PROTECTION CONTROLS INC. SKOKIE, ILLINOIS			
CONTACT CONFIGURATION FOR V2N4T911-UL OFF-RUN-IGNITION SWITCH AS USED ON UNIFIED CONTROL PANEL NO. 62021			
JOB NO.	DRAWN BY	DATE:	DRAWING NO.
	R.N.	9-21-01	X-375

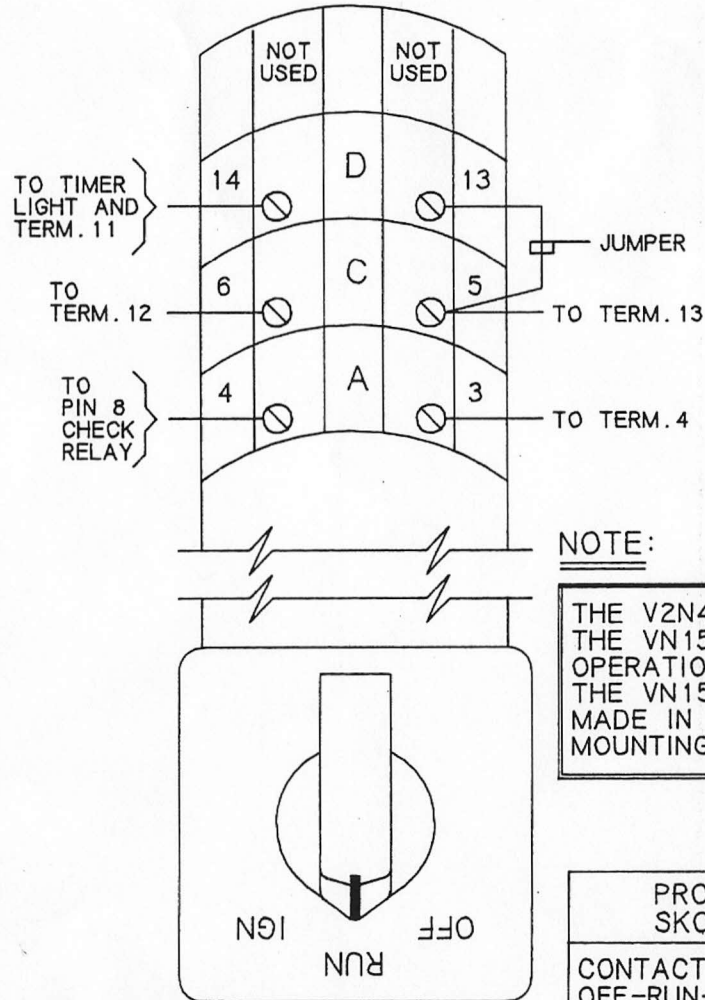
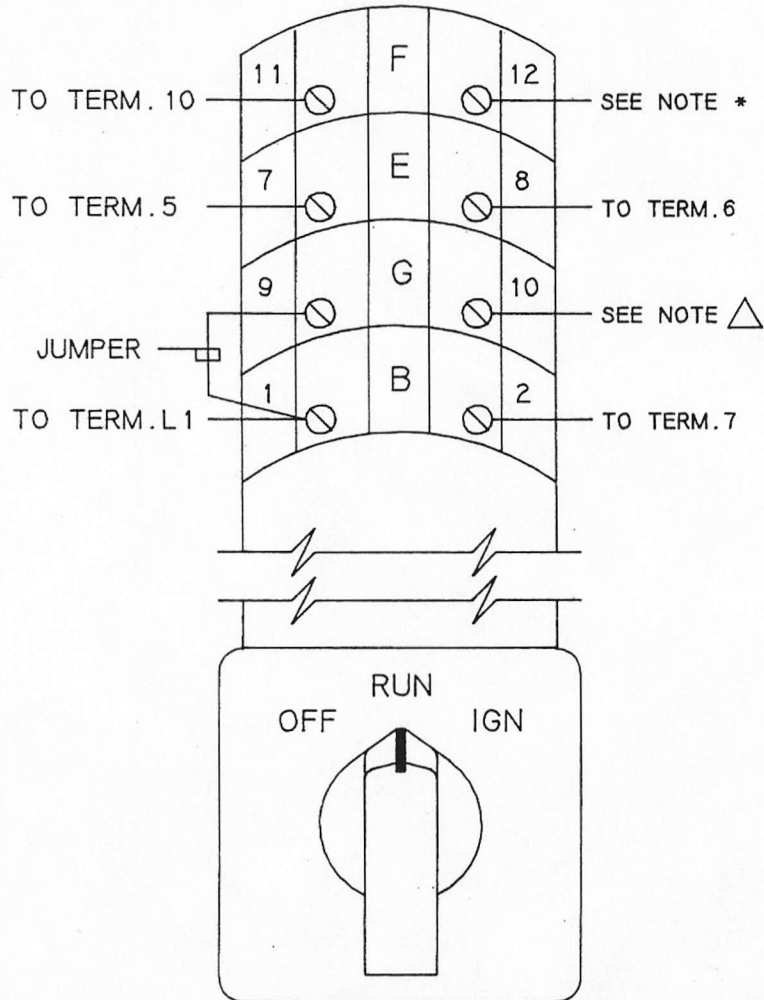
THE V2N4T911-UL SWITCH SUPERSEDES
THE VN154T911-UL AND IS IDENTICAL IN
OPERATION. IF IT IS USED TO REPLACE
THE VN154T911-UL, A NOTCH MUST BE
MADE IN THE TOP OF THE EXISTING
MOUNTING HOLE TO PREVENT ROTATION.
